ADDENDUM NO. 1
CONTRACT NO. CP8126-1 – GENERAL, MECHANICAL AND
ELECTRICAL CONSTRUCTION
DATED: SEPTEMBER 10, 2010

**SUFFOLK COUNTY DEPARTMENT OF PUBLIC WORKS
DIVISION OF SANITATION
HAUPPAUGE INDUSTRIAL PARK
S.C.S.D. NO. 18 – INDUSTRIAL SEWER DISTRICT EXPANSION
SUFF 0503**

ADDENDUM #1 - ITEM R2
SHEET EPT2 - SKETCH # 9

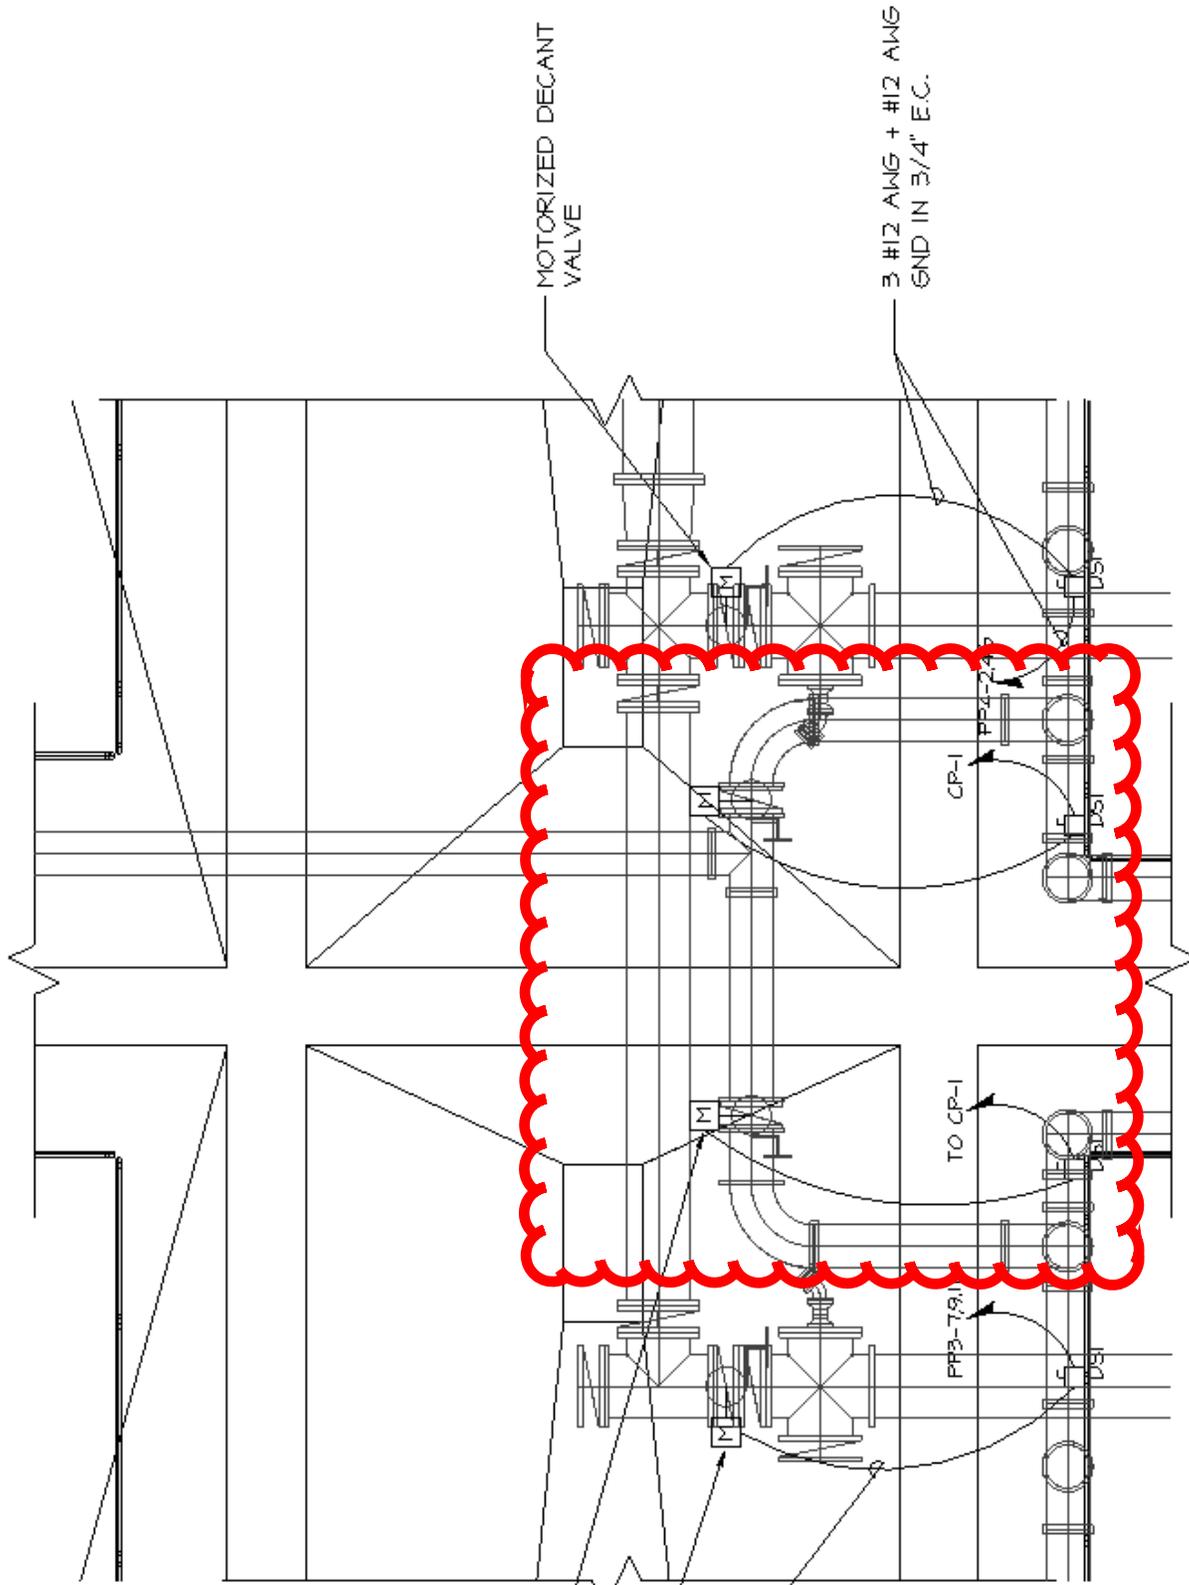
1. Shift location of multi-use tank motor south to show it being within sump along south wall of tank.
2. Add POST EQUALIZATION PUMP (POEQP-3) within sump along south wall of SOUTH POST-EQ tank along with associated control wiring as shown on Sketch #9 included herein.

SHEET EPT4 - SKETCH # 10

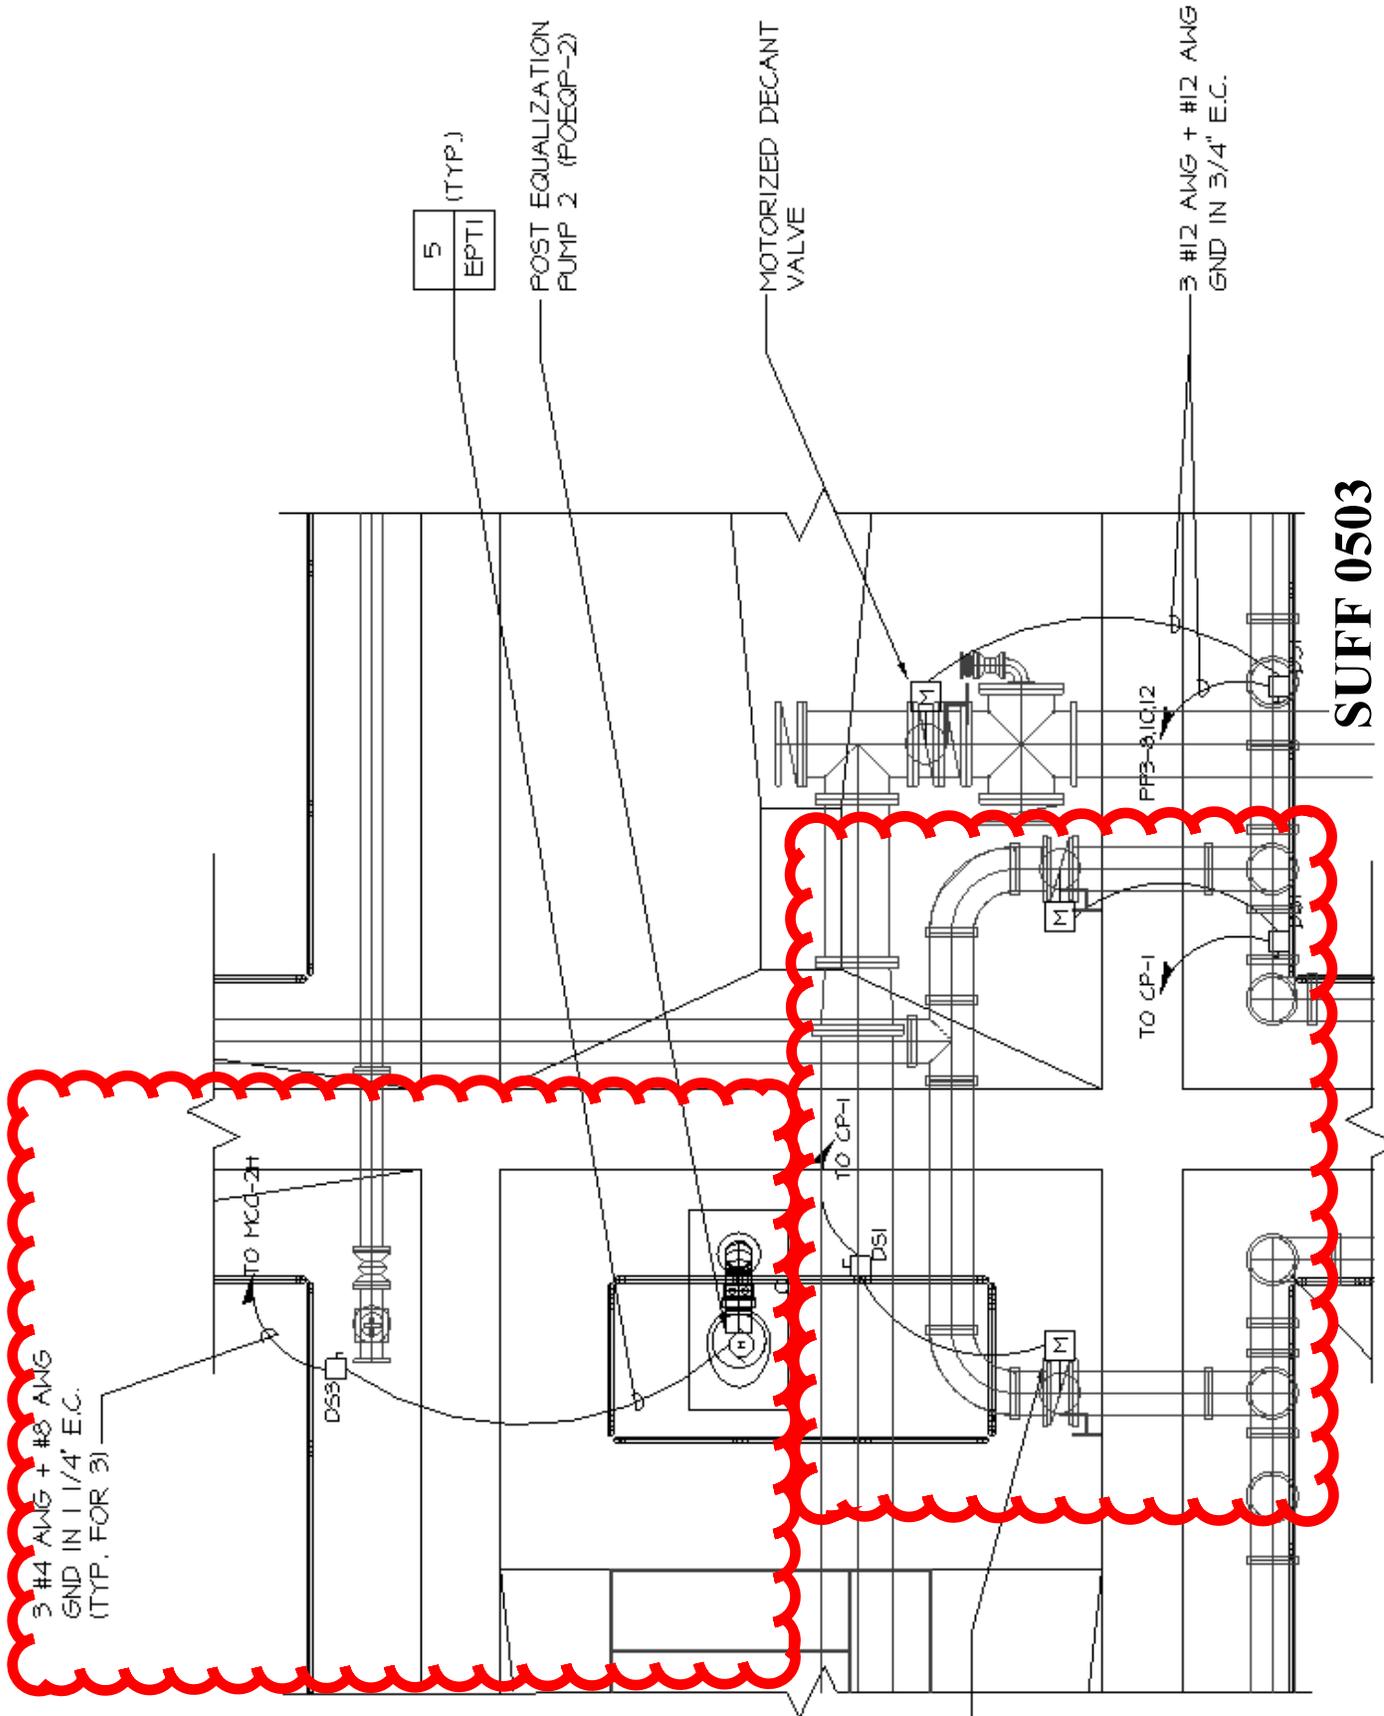
1. Detail entitled ENLARGED NORTH/CENTRAL SBR MOTORIZED VALVE POWER PLAN:
 - a. Remove POST-EQUALIZATION PUMP 2 (POEQP-2) and all associated power wiring.

- b. Add disconnect switches and associated wiring for the motorized air valves.
 - c. Above revisions as shown on Sketch #10 included herein.
2. Detail entitled ENLARGED NORTH/CENTRAL SBR MOTORIZED VALVE CONTROL PLAN: Remove POST-EQUALIZATION PUMP 2 (POEQP-2) and all associated control wiring.

ADDENDUM #1 - ITEM S3
SHEET EPT4 - SKETCH # 11

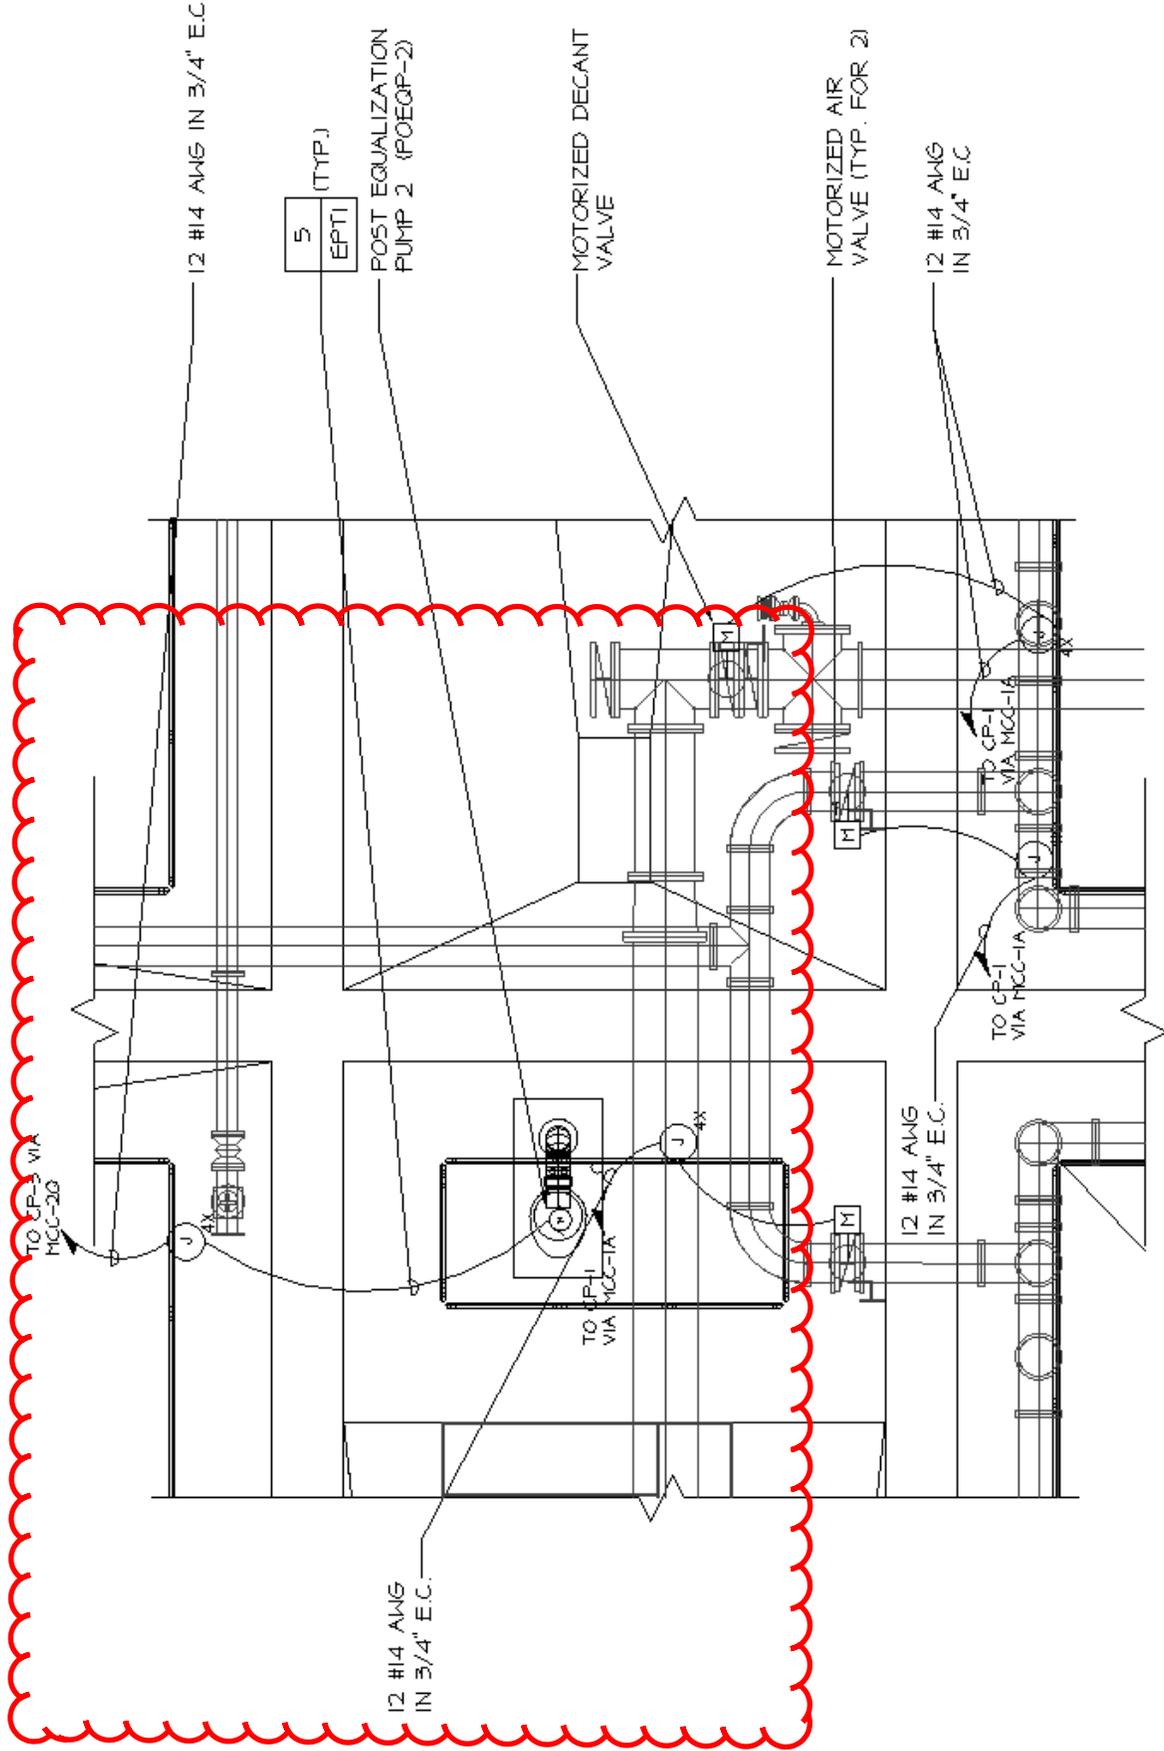
3. Detail entitled ENLARGED CENTRAL/SOUTH SBR MOTORIZED VALVE POWER PLAN:
 - a. Remove POST-EQUALIZATION PUMP 3 (POEQP-3) and all associated power wiring.

- b. Add POST-EQUALIZATION PUMP 2 (POEQP-2) and all associated power wiring.
 - c. Add disconnect switches and associated wiring for the motorized air valves.

- d. Above revisions as shown on Sketch #11 included herein.
4. Detail entitled ENLARGED CENTRAL/SOUTH SBR MOTORIZED VALVE CONTROL PLAN:

SUFF 0503
 ADDENDUM #1 - ITEM II
 SHEET EID4 - SKETCH # 16

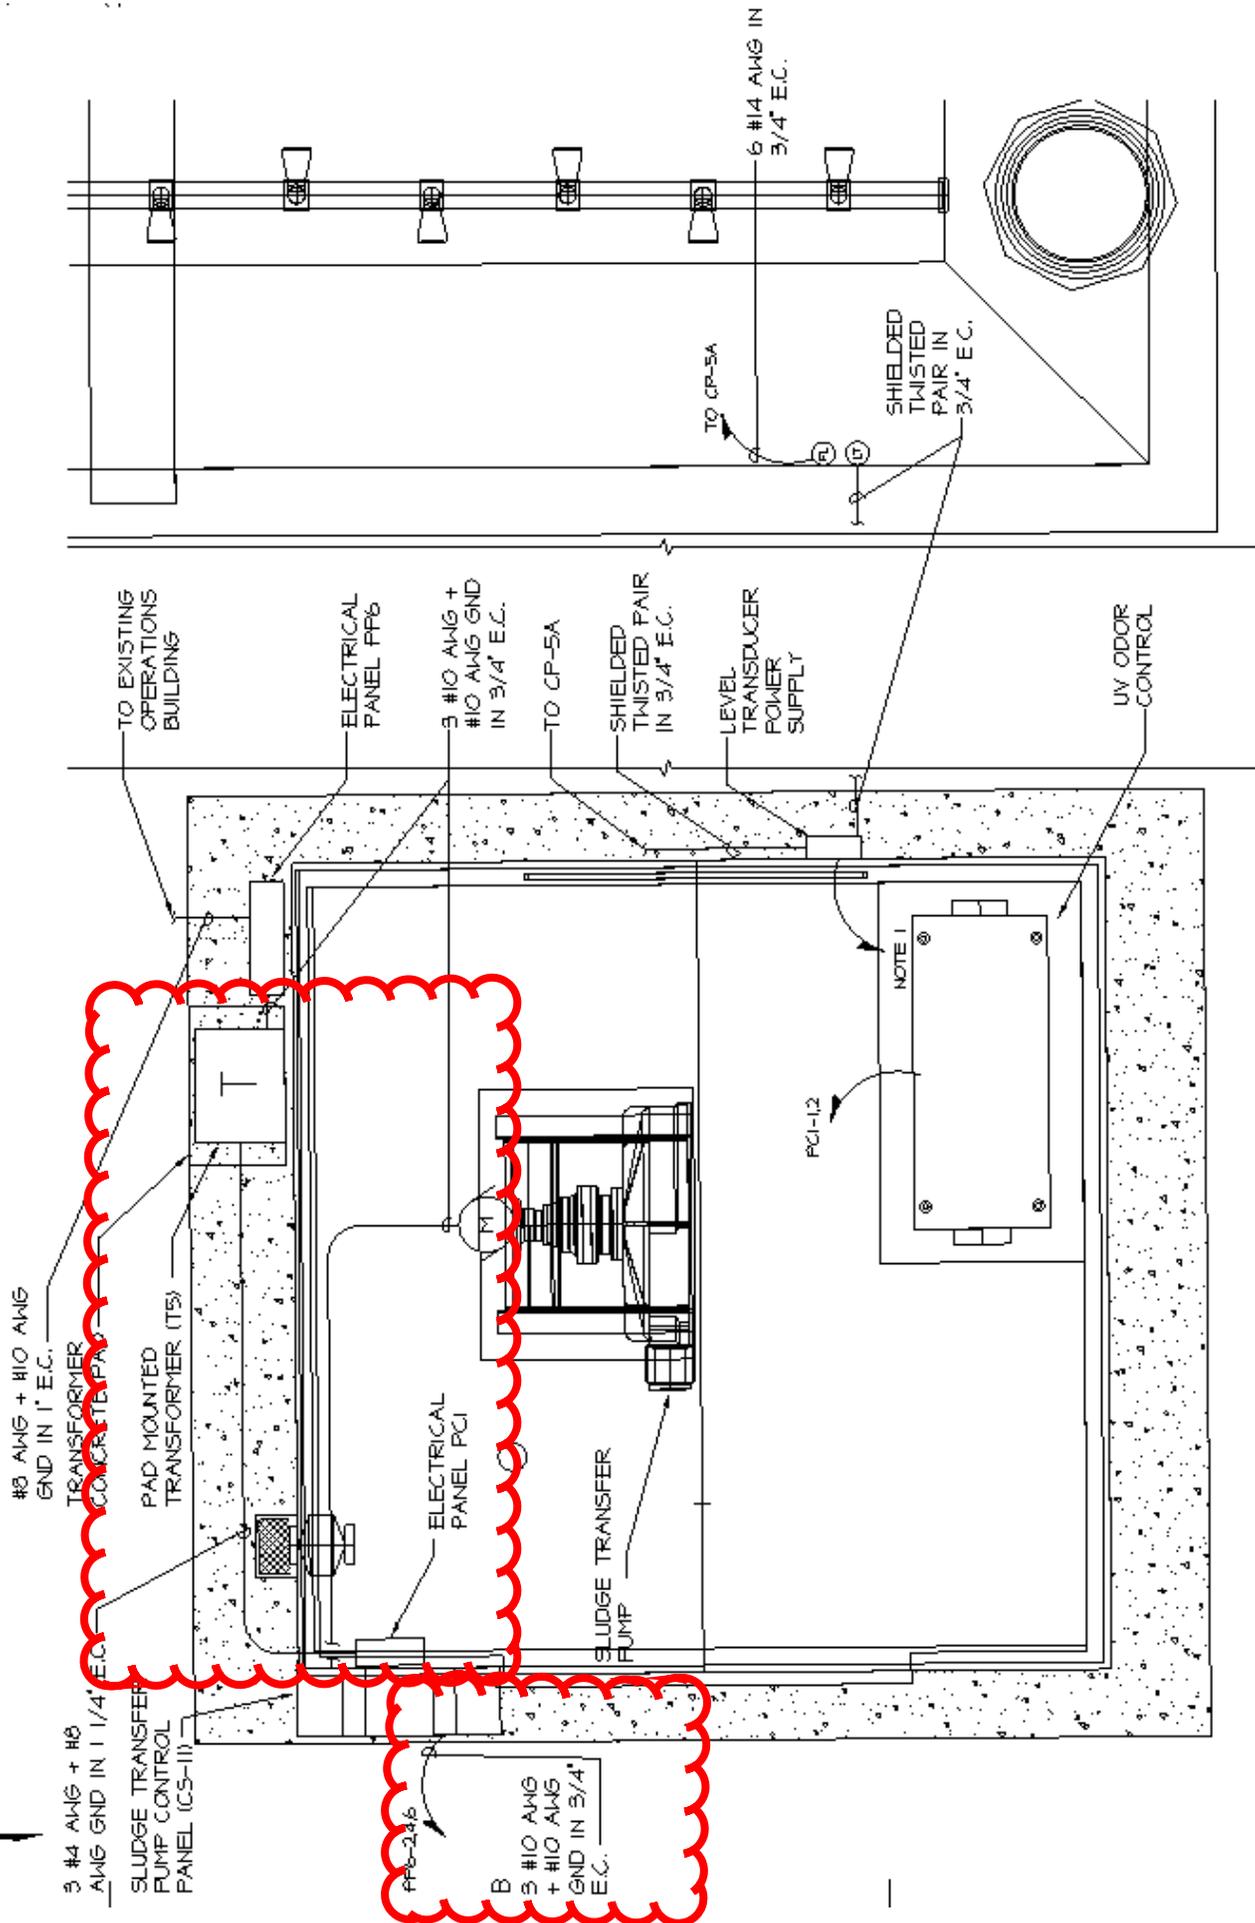
1. Detail #3:
 - a. Modify location of homerun going to PP6-2,4,6 to emanate from CS-11 rather than electrical panel PP6.
 - b. Modify wiring routed from the left of transformer T5 to connect to PC-1.
 - c. Above revisions as shown on Sketch #16 included herein.

SUFF 0503
ADDENDUM #1 - ITEM MM
SHEET H5 - SKETCH # 17

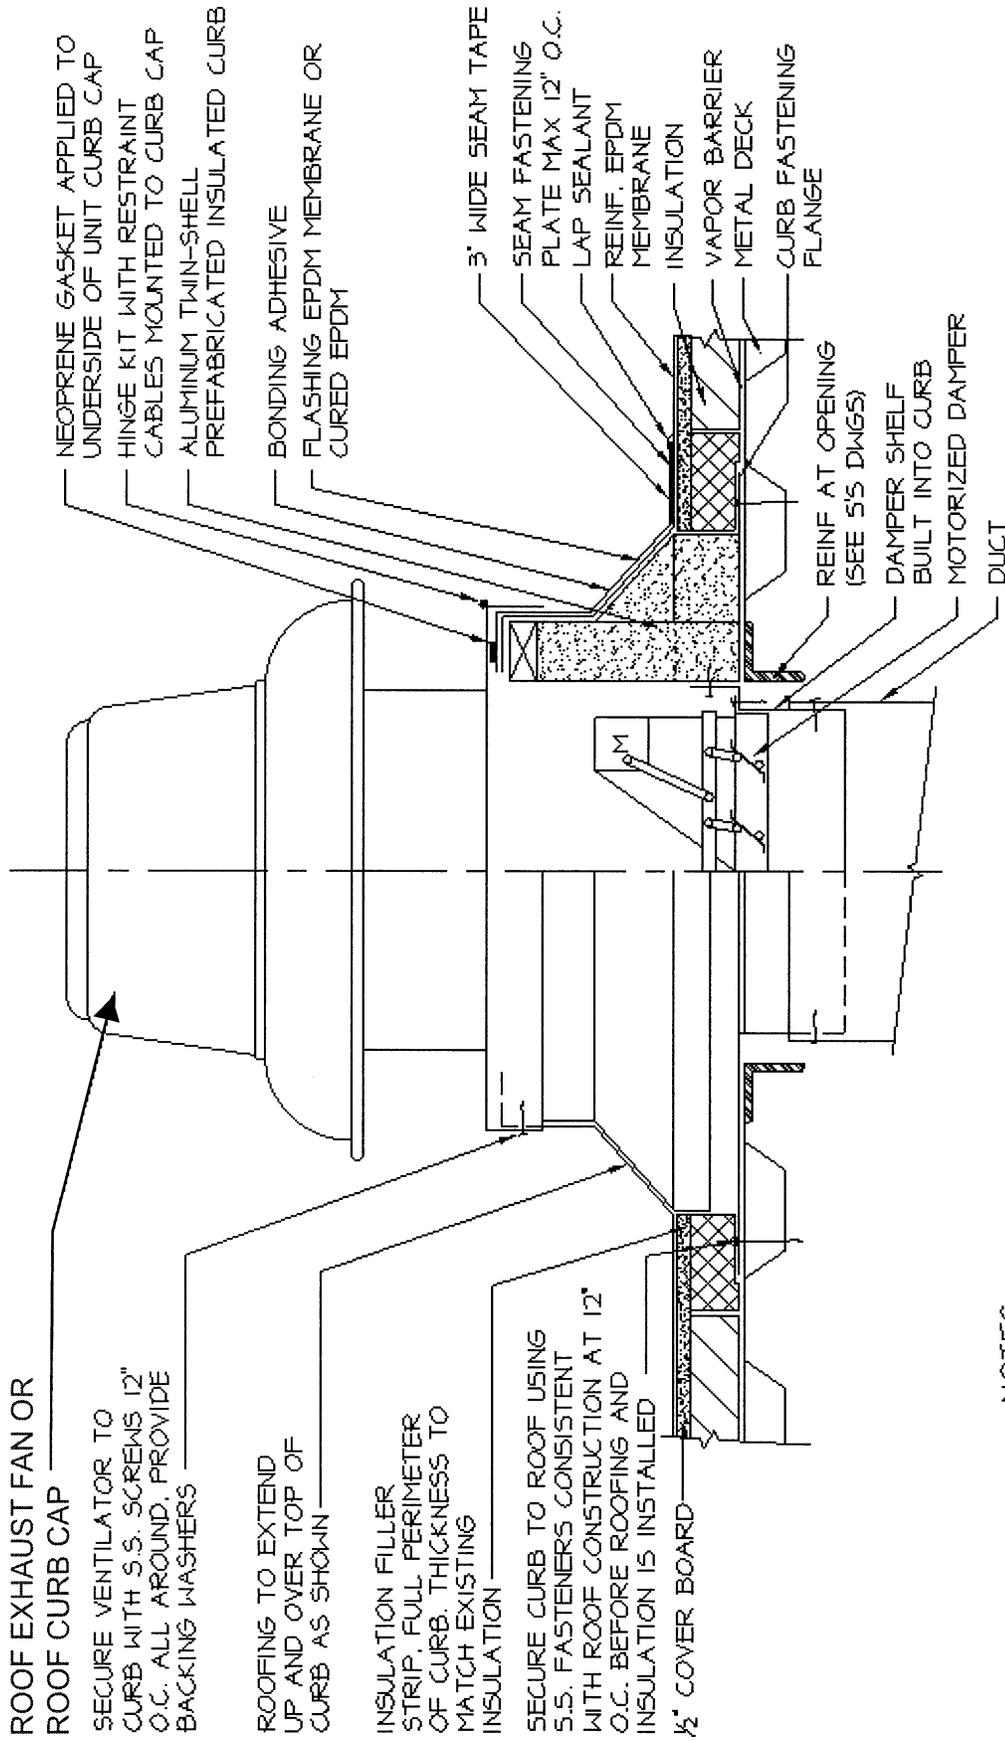
1. The options currently noted in the Exhaust Fan Schedule for TX-1 shall be disregarded. Exhaust fan TX-1 shall be provided with the following options:
 - a. Curb mounted roof cap
 - b. Designer grille

- c. Motor with thermal overloads
- d. Solid state speed controller
- e. Prefabricated roof curb (12")
- f. EXHAUST FAN SCHEDULE modified as shown on Sketch #17 included herein.
